Access Compliance Report

Public Rights-of-Way

(Pedestrian Signals)

Intersection ID: N/A	Main Street:	Cross Street: N/A	Location: N/A
ADA ID: C7D67354C2A8	Signal Type: One Push Button-Non APS	Overall Compliance: No	Severity Score: BTN 1: N/A BTN 2: N/A No BTN: N/A
Codes/Mitigation Info/Possible Solution		Field Measurements/Component Compliance

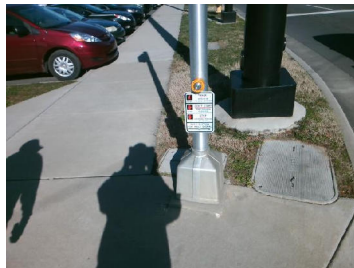
Possible Solutions: Provide Push Button Extension. Remove and Replace Clear Space.

PROW/ADA: R404.2, R404.3, R406.2
